# Access Compliance Report

## Public Rights-of-Way

### (Curb Ramps)

Intersection ID: 9018	Main Street: GRANT_ST	Cross Street: LAKEWOOD_AV	Location:	N
ADA ID: 70E0559AB269	Ramp Type: Perp	Initial Pass/Fail: Fail	Overall Compliance: No	Severity Score: 60
Codes/Mitigation Info/Possible Solution		Field Measurements/Component Compliance

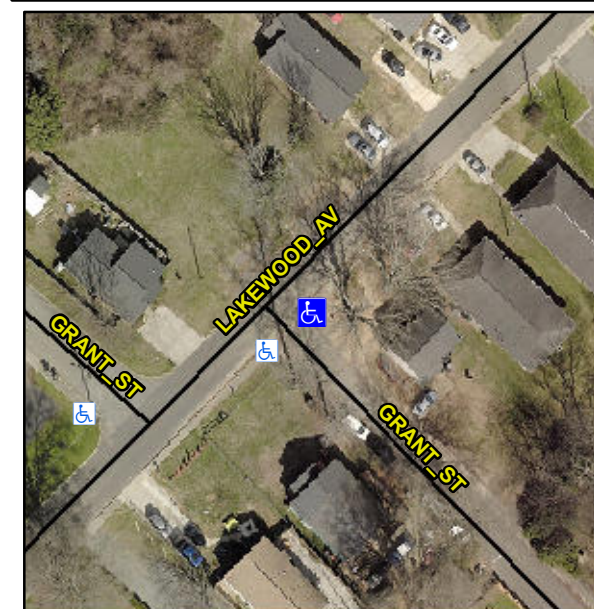
**R304.5.1, R304.2.2**

Compliance	Description	Data	Compliance	Description	Data
N/A	Ramp Length (in)	53.0	No	Ramp Slope (%)	17.7
No	Ramp Width (in)	24.0	Yes	Ramp XSlope (%)	1.7
N/A	Flare Type LT	N/A	N/A	Flare Type RT	N/A
N/A	Flare Slope LT (%)	N/A	N/A	Flare Slope RT (%)	N/A
N/A	Flare Traversable LT?	N/A	N/A	Flare Traversable RT?	N/A
N/A	Landing Length (in)	N/A	N/A	DWS Provided?	N/A
N/A	Landing Width (in)	N/A	N/A	DWS Contrast?	N/A
N/A	Landing Slope (%)	N/A	N/A	DWS Length (in)	N/A
N/A	Landing X Slope (%)	N/A	N/A	DWS Full Width?	N/A
N/A	Landing Curb? (Y/N)	N/A	N/A	DWS Offset (in)	N/A
N/A	Shared Landing?	N/A			
N/A	Gutter Ponding?	Yes	N/A	Gutter Slope (%)	N/A
N/A	Gutter Lip Ht (in)	N/A	N/A	Gutter X Slope (%)	N/A
N/A	Painted X Walk1?	No	N/A	Painted X Walk2?	N/A
	X Walk 1 Direction	To SW		X Walk 2 Direction	N/A
N/A	X Walk 1 Width (in)	N/A	N/A	X Walk 2 Width (in)	N/A
	X Walk 1 Slope (%)	0.1		X Walk 2 Slope (%)	N/A
	X Walk 1 X Slope (%)	4.8		X Walk 2 X Slope (%)	N/A

**Remove & Replace Entire Ramp.**
